KNOXVILLE HISTORIC ZONING COMMISSION STAFF REPORT - CERTIFICATE OF APPROPRIATENESS APPLICATION

PROPERTY ADDRESS: 9320 Kingston Pike 37922 FILE NO.: 2-E-14-HZ

LEVEL OF WORK: Level II. Construction of addition or outbuilding

Walker-Sherrill House – Proposed rear porch enclosure 2-20-14

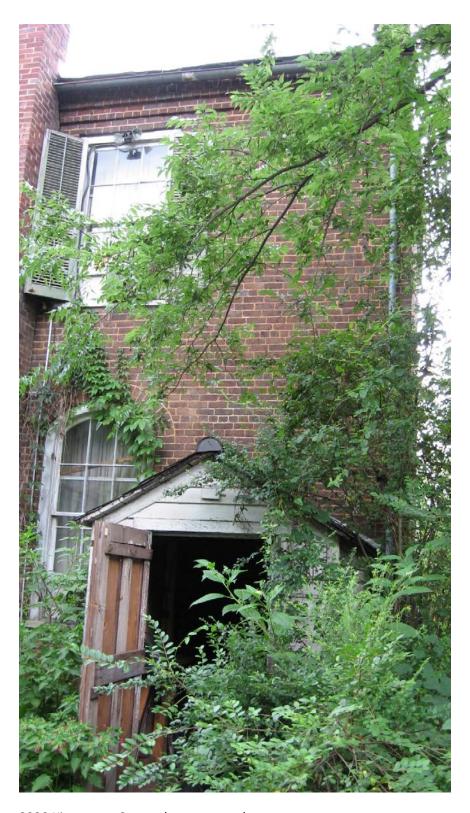
- 1) The design proposal and wooden materials for the rear frame addition and enclosed stair are based on documentary photos.
- 2) The date of the enclosures shown in the 2007 photos is not known, but were likely constructed sometime between the 1920s and 1940s.
- 3) The rear porch was screened-in at the time of the historic resource survey, but had been demolished in more recent years.
- 4) Locating the restrooms and part of the fire exit stair in this addition will preservet the original floor plan and servant stairs in the rear of the house.
- 5) Enclosing the rear steps to the basement will help preserve the house by keeping moisture out of the basement entrance.
- 6) The proposed driveway and parking layout will eliminate the drive ailse in front of the house and allow for more grassed area and landscaping there, which is more appropriate for the context of the house.

Approval for rear frame addition, enclosed steps to the basement, and parking and drive ailse as shown on the plan submitted 1-30-2014.
